Re: Chevron Facility # 9-1583

Address: 5509 Martin Luther King Jr. Way, Oakland, CA

Re: **Soil Vapor Investigation Workplan**  
Chevron Service Station 9-1583  
5509 Martin Luther King Jr. Way  
Oakland, California

Subject: Fuel Leak Case RO0000002 & Global ID T0600100348, 5509 Martin Luther King Jr. Way, Oakland, CA 94609

**Site Plan**

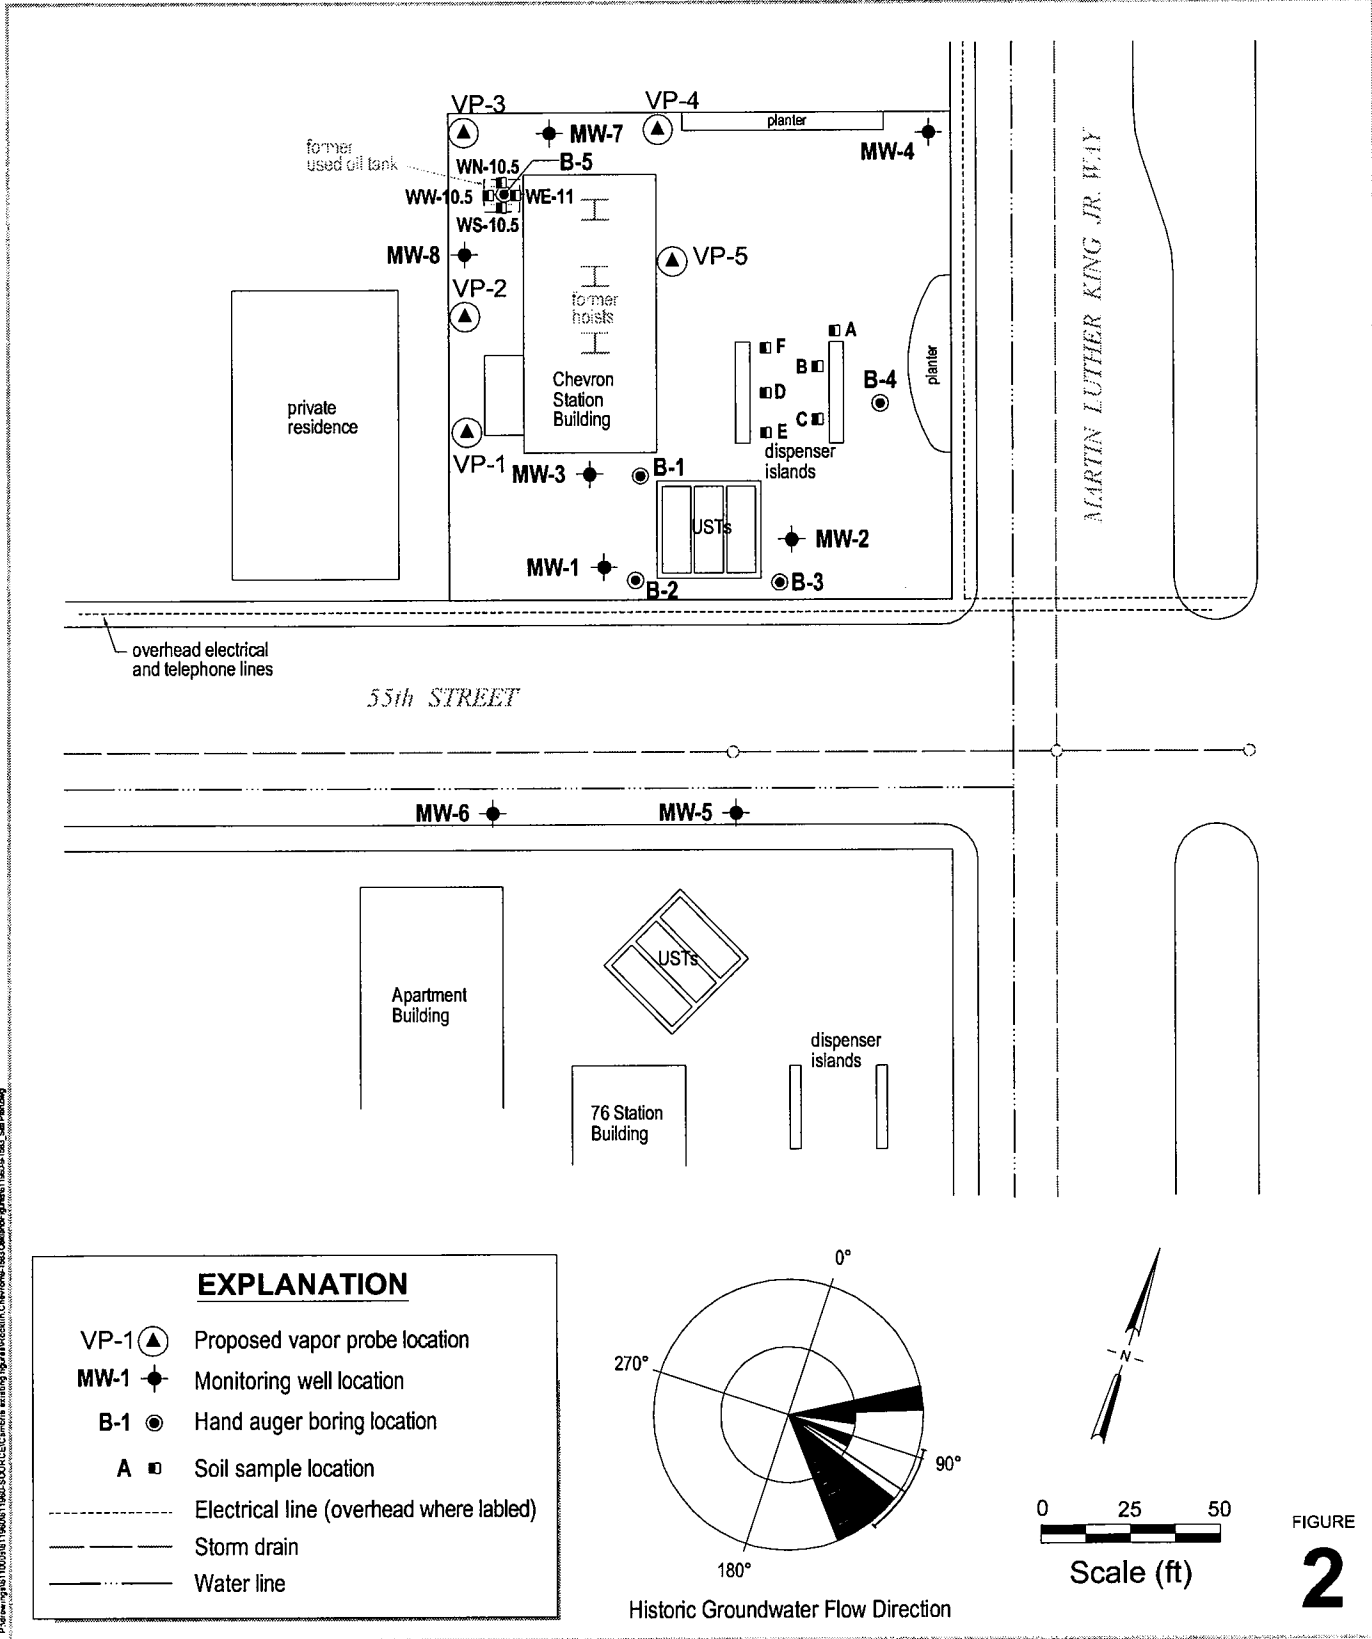
1. Borings Around Former Fuel USTs- Soil samples from 3-9' bgs from the three boring indicate that no shallow contamination exists in the immediate vicinity of the former UST tank pit. Grab groundwater samples from B-1 and B-2 from 11-12' bgs, however, were contaminated with up to 4500 ppb TPHg, which may be residual contamination from historic releases also detected in MW-1 and MW-3. This suggests that there may have been impacted soil or groundwater below the depths of these borings and that groundwater gradient has not always been to the southeast as depicted in monitoring reports. Please provide an explanation or plausible SCM, which explains this data. Propose additional investigation, if necessary. We request soil vapor sampling be done to evaluate potential risks from fuel releases to both on and off-site properties.

3. Waste Oil Tank Area- The historic presence of TPHg and MTBE in wells MW-7 and MW-8 near the former waste oil tank, has not been explained. As mentioned previously, the inability to collect deep soil and groundwater samples from the former pit leaves this area still in question. Was the historic elevated TPHg, BTEX and MTBE contamination in MW-8 from the former waste oil tank or is there another source for these contaminants either on or off-site? Has this contamination migrated off-site and affected neighboring properties? Please provide an explanation or plausible SCM, which explains this data. Propose additional investigation, if necessary. We request soil vapor sampling be done to evaluate potential risks from fuel releases to both on and off-site properties.

CRA proposes advancing five hand augered soil borings, which will be completed as permanent soil vapor probes. The probes will be used to collect soil vapor samples to evaluate the potential risks from fuel releases to both on and off-site properties. The vapor probe borings will be advanced to approximately 6 fbg; actual depths may be changed depending on the depth to water observed during field work. The locations of the proposed borings are indicated on Figure 2. CRA's standard field procedures are presented as Attachment B.

***Soil Vapor Probe Installation:*** CRA proposes to advance five shallow hand-auger borings which will be completed as soil vapor probes at the approximate locations shown on Figure 2. The total depth of each boring will be approximately 6 fbg, and the bottom of each vapor probe will be approximately 5.5 fbg. Soil samples will be collected at approximately 3 fbg using a slide hammer and a drive-core barrel. The borings will be continuously logged by CRA field personnel. The final locations of the borings will be based on site and utility constraints as evaluated in the field.
